IRF19/5834

Gateway determination report

LGA	Fairfield City
PPA	Fairfield City Council
NAME	Cabramatta Town Centre East (582 homes, 369 jobs – subject to recommended amendment of the planning proposal)
NUMBER	PP_2018_FAIRF_003_00
LEP TO BE AMENDED	Fairfield LEP 2013
ADDRESS	Land bounded by Fisher Street, Broomfield Street and Cabramatta Road East, Cabramatta
DESCRIPTION	Various allotments
RECEIVED	25 March 2019
FILE NO.	IRF18/5834
POLITICAL DONATIONS	There are no donations or gifts to disclose and a political donation disclosure is not required.
LOBBYIST CODE OF CONDUCT	There have been no meetings or communications with registered lobbyists with respect to this proposal.

Figure 4: Council-endorsed heights.

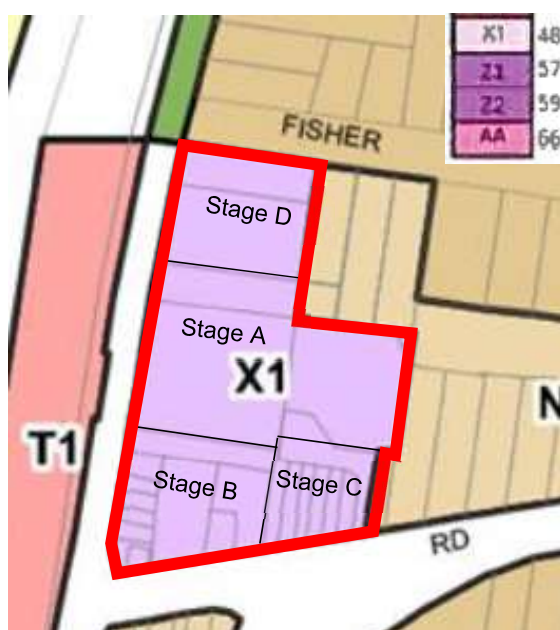
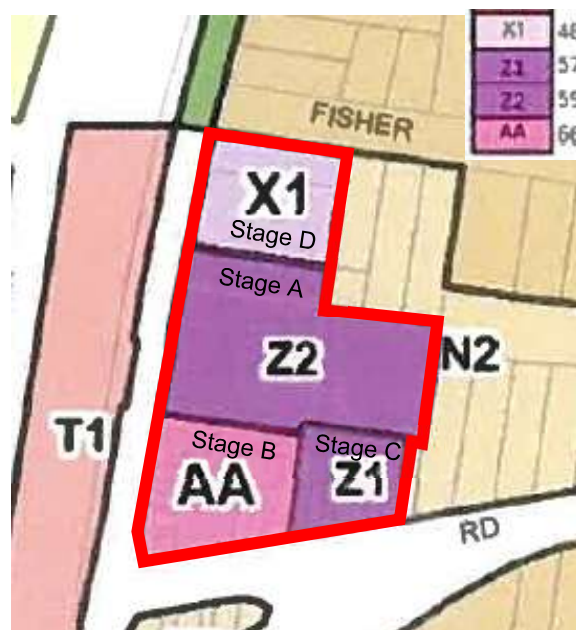
As shown in Table 2 (above), there is a height difference for three of the proposed buildings (i.e. Stages A, B & C). For Stages A and C, the height difference is related to the double ceiling height for the two commercial floors (i.e. approx. 5.5m and 4.5m per floor respectively). Whilst, the height difference for Stage B is attributed to the additional five residential floors.

The Department considers that the visual impact of an additional four storeys (i.e. 19 storeys compared to 15 storeys) on the corner of Cabramatta Road East and Bloomfield Street would be minor from the street level and the surrounding public domain.

Further, there is no justification, or studies, provided by Council to support the blanket 48m building height for the site. In addition, the blanket building height of 48m and the identified FSRs of 2.5:1 to 3.85:1, 4:1, 6.1:1 and 6.45:1 for the site are not considered to be compatible. The built form outcome of the proposed development based on these development standards would result in an entirely different building compared to the version assessed by council officers, the Fairfield Local Planning Panel, and the independently appointed urban designers.

Taking these matters into consideration, the Department recommends that Council amends the proposed maximum building height to be consistent with the heights originally assessed and supported by council officers and the Fairfield Local Planning Panel, i.e. a maximum building height of 48m (approx. 12 storeys), 57m (approx. 16 storeys), 59m (approx. 16 storeys), and 66m (approx. 19 storeys).

The current and proposed maps are shown in Figures 8–13 (next page).

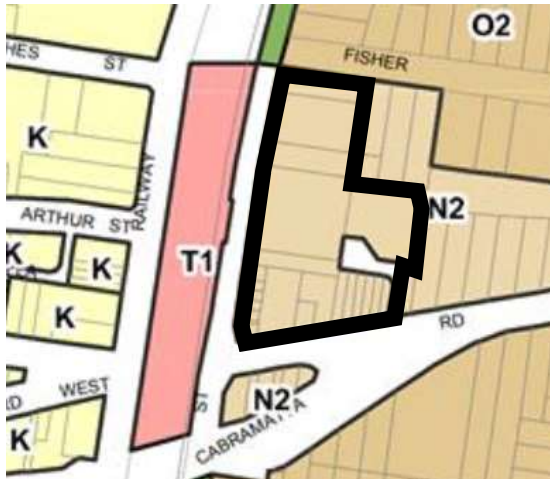
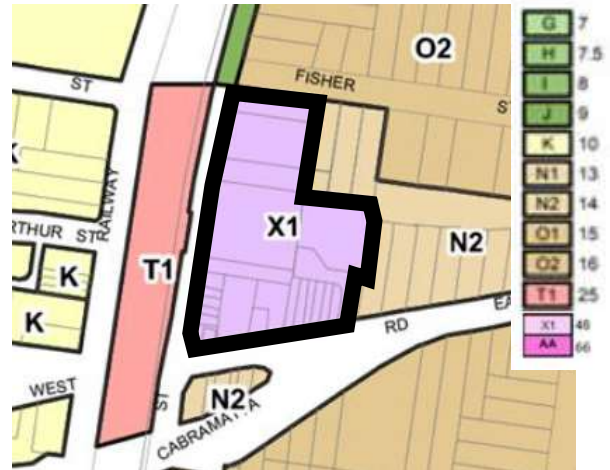
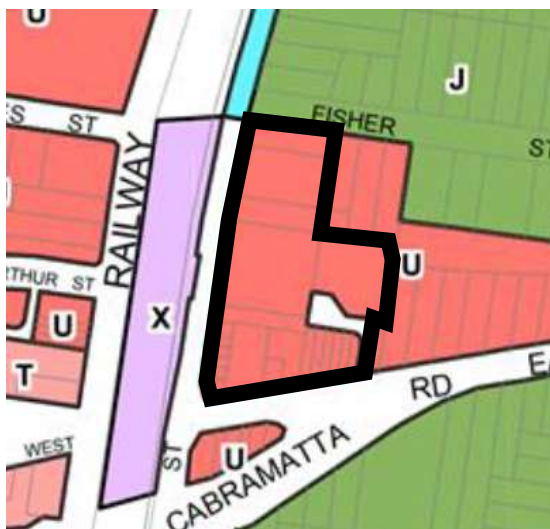
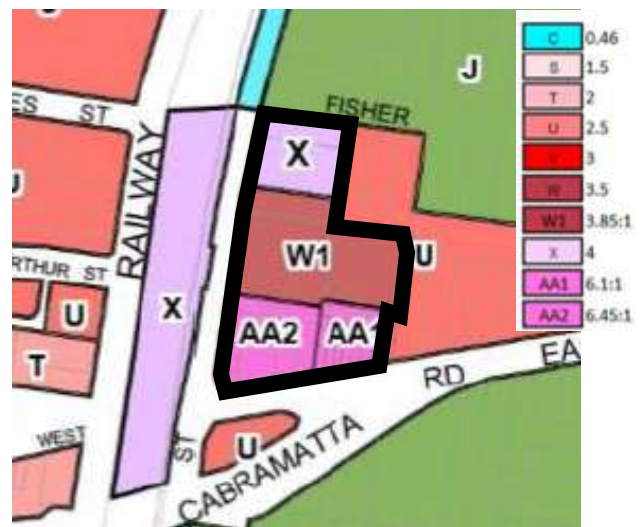
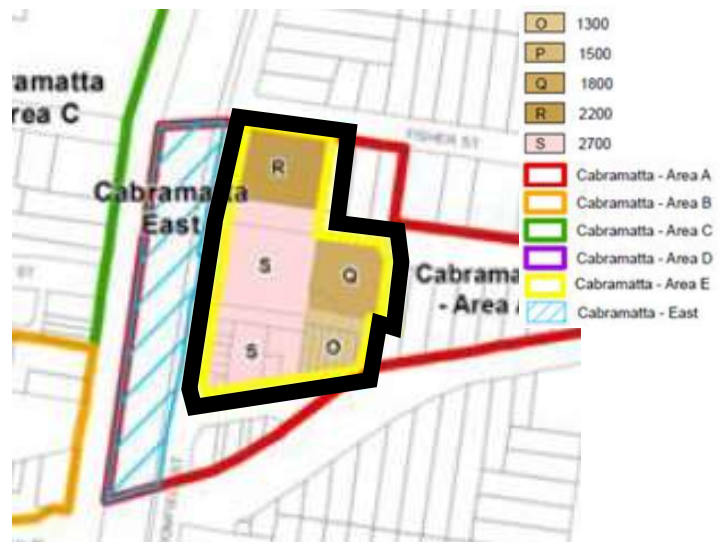
It is recommended that prior to public exhibition, Council includes a clear outline of the site in the current and proposed maps in Appendix A.2 of the planning proposal to provide clarity to the community about the extent of the site and the proposed amendments.

Figure 14: Precinct 4 map in the existing DCP.

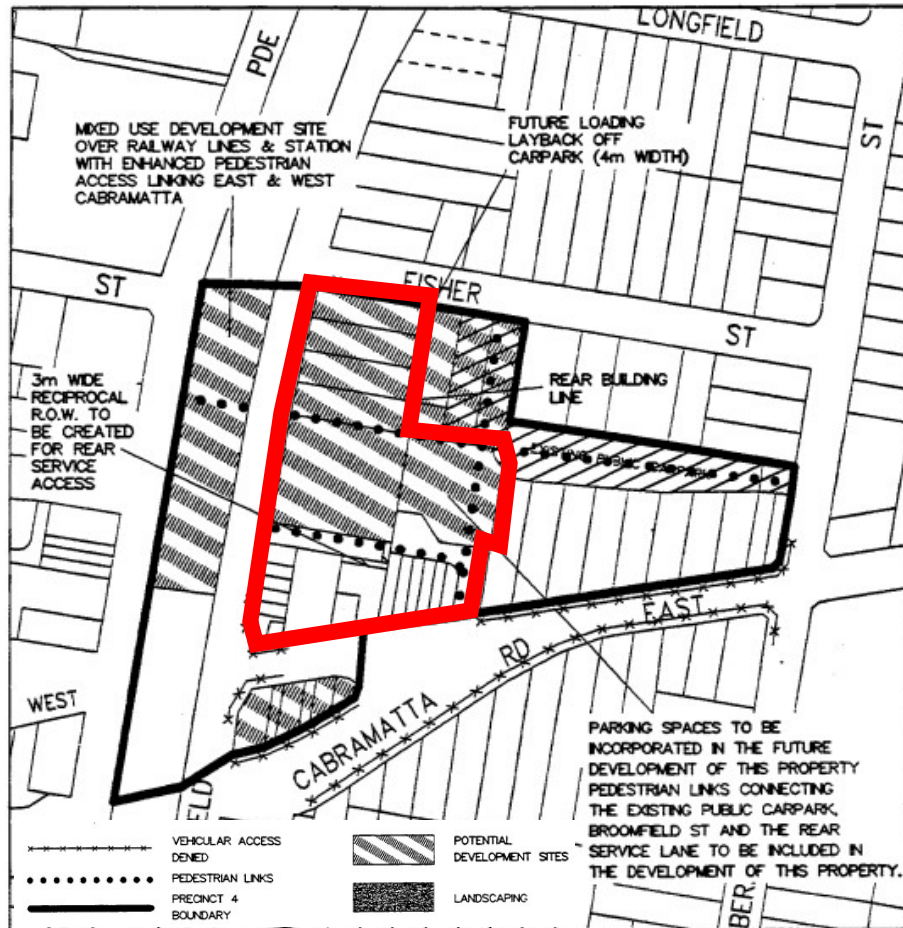
The Department notes that Council proposes to prepare a site-specific DCP for the site and the Department has included a Gateway condition requiring that this DCP be exhibited with the planning proposal. However, Council has not advised whether the existing DCP will be amended and therefore two DCPs would apply to the site.

Prior to exhibition, it is recommended that Council amends the planning proposal to include the intent to amend the existing DCP to incorporate the site-specific development controls so there is only one set of development controls in the DCP associated with the site.

Figure 15: Obstacle limitation surfaces for Bankstown Airport.

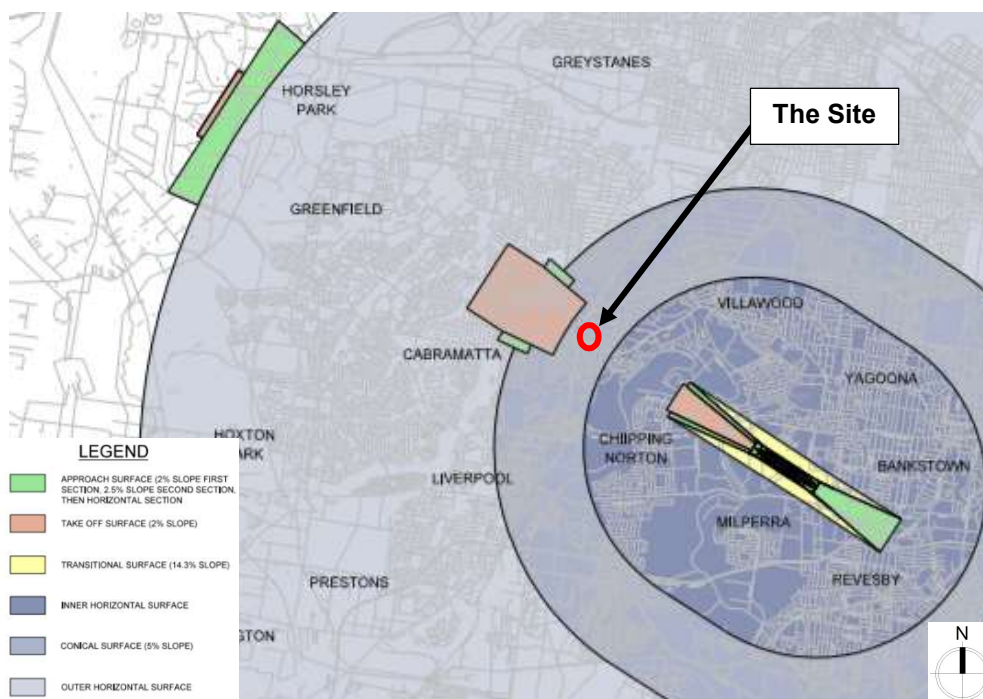
The proponent has undertaken preliminary consultation with Bankstown Airport, which subsequently recommended the proposal be referred to Airservices Australia. Airservices Australia has advised that a maximum height of 66m will not affect sector or circling altitude, any instrument approach or departure procedure at Bankstown Airport, or the performance of any Airservices Precision/Non-Precision Nav Aids, Anemometers, HF/VHF/UHF Comms, A-SMGCS, Radar, PRM, ADS-B, WAM or Satellite/Links.

However, to be consistent with this Direction, Council is required to consult the relevant airport service providers in the preparation of the planning proposal. Therefore, Council should consult the relevant airport authorities prior to public exhibition to be consistent with this Direction.

Figure 16: Flood-prone land map.

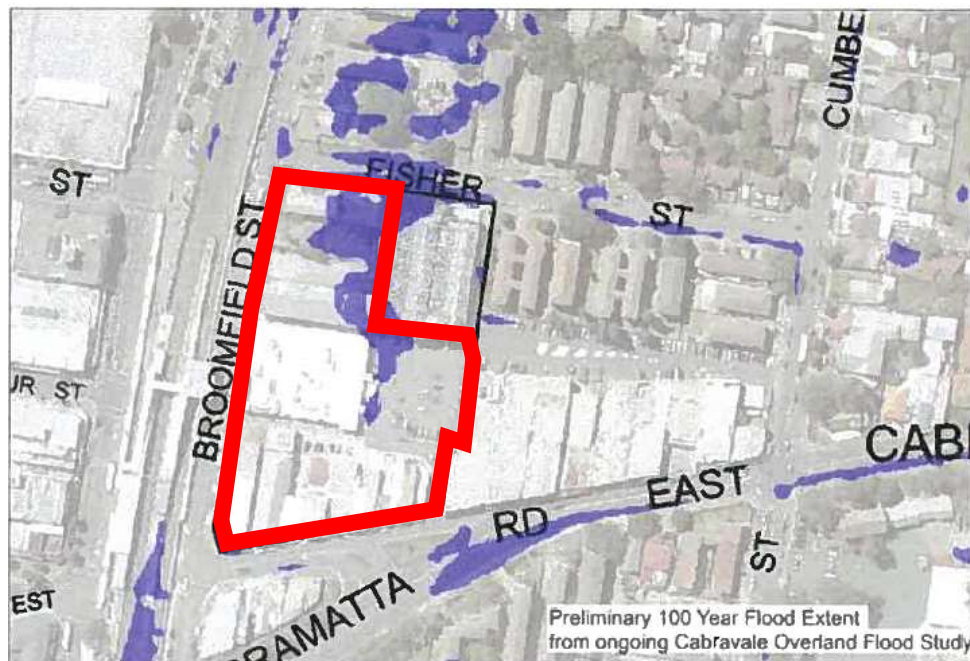
The planning proposal is inconsistent with this Direction as it permits a significant increase of the permissible development across the flood-affected land on the site.

Council's Catchment Planning Branch did not object to the planning proposal subject to any future development proposal addressing flooding and stormwater constraints likely to occur as a result of the development. The proposal states that these matters will be addressed at the development application stage.

Therefore, to ensure that the planning proposal complies with the requirements of this Direction, it is recommended that Council addresses this inconsistency further and consults the Office of Environment and Heritage to determine if there are any flooding issues with the proposed development and, if necessary, seeks the agreement of the Secretary to justify any inconsistency with this Direction.

The proposal states that these matters will be addressed at the development application stage. It is recommended that Council consults the Office of Environment and Heritage on the flooding impacts of the planning proposal during the public exhibition period.
